CHERRY LODGE GOLF CLUB, BIGGIN HILL

REVISED CONSTRUCTION TRAFFIC MANAGEMENT STATEMENT

REPORT REF. F990-02A
PROJECT NO. F990
OCTOBER 2011

Road Safety Audit Stage 1

Plan attached showing the locations of the problems identified as part of this audit (location numbers refer to paragraph numbers in the report).

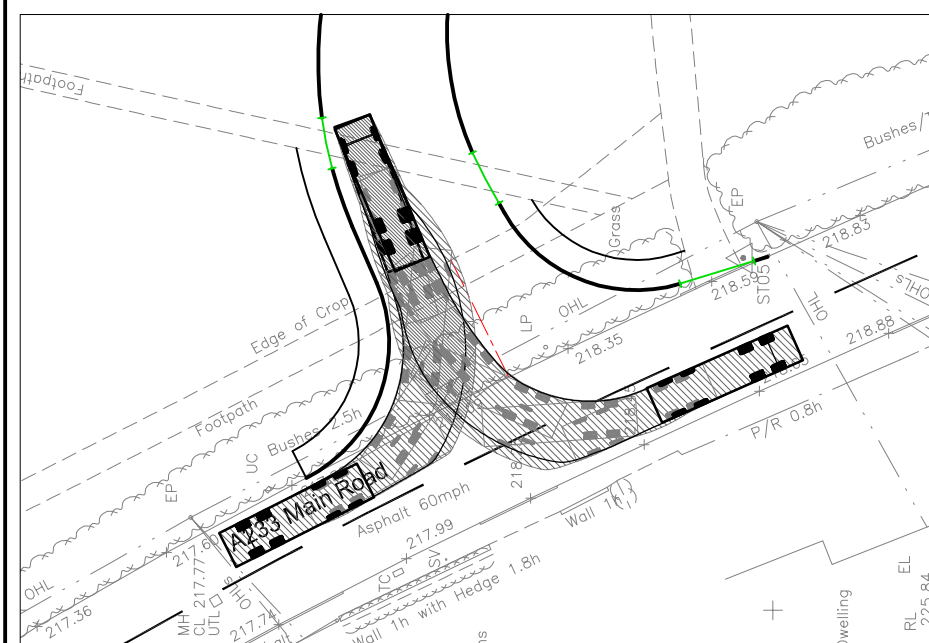
Location: Junction of the Access Road and Main Road

Summary: Ponding of surface water could lead to loss of control accidents.

No details of drainage or vertical profiles have been provided for the junction, any ponding on Main Road could lead to loss of control accidents.

That drainage details and carriageway profiles be provided at safety audit stage 2.

Location: Junction of the Access Road and Main Road.

Summary: Lack of visibility may lead to side impact accidents.

It is proposed that the visibility splays are 57m and 53m and are based on a 2m height above carriageway level. It was noted that from the Construction Traffic Management Statement that the visibility distances from Manual for Streets have been used. It would appear that greater visibility distances in accordance or possibly in excess of the requirements of TD42/95 could be achieved with minimal vegetation trimming.

That as the haul route will be used for a 18-24 month period, with slow moving traffic exiting the junction that consideration be given to increasing the visibility splays.

Location: Junction of the Access Road and Main Road.

Summary: Lack of visibility may lead to side impact accidents.

In the Construction Traffic Management Statement, it is stated that the haul route is to be used exclusively by HGVs. However, it is unclear how this will be enforced and should other traffic egress from the site then the visibility splays would be insufficient.

That details be provided, as to how HGV only controls would be introduced or that consideration be given to introduce visibility splays suitable for all vehicle types.

Location: Junction of the Access Road and Main Road.

Summary: Absence of street lighting may lead to accidents during the hours of darkness.

The proposal places the junction where there is an existing street lighting column. No details have been supplied, as to additional lighting or where the removed column is to be repositioned. A reduction in the luminance on Main Road may give rise to accidents during the hours of darkness. Furthermore should the spacing between columns be too great then the current 30mph speed limit may not apply.

That street lighting details be provided at safety audit stage 2.

Audit Item No.	Problem accepted (yes/no)	Recommended measure accepted (yes/no)	Alternative Measures (describe)	Alternative measures accepted by Audit Team (yes/no)
4.2.1	Yes	Yes	N/A	
4.3.1	Yes	Yes	Visibility splay "Y" distance requirements are based on Stopping Sight Distances commensurate with observed 85 th percentile speeds derived from the Manual for Streets, as agreed with LBB. If LBB consider that the "Y" distances should be increased to 90m (for a road with a 30mph speed limit) in accordance with TD 42/95 then this could be achieved by cutting back more of the existing hedgerow.	Yes
4.3.2	Yes	Yes	Visibility splay requirements will be based on standard car driver eye heights of 1.05m with the hedgerow trimmed above this height. In addition, gates will be provided behind the route of the public footpath which will be closed outside of site operating hours.	Yes
4.5.1	Yes	Yes	N/A
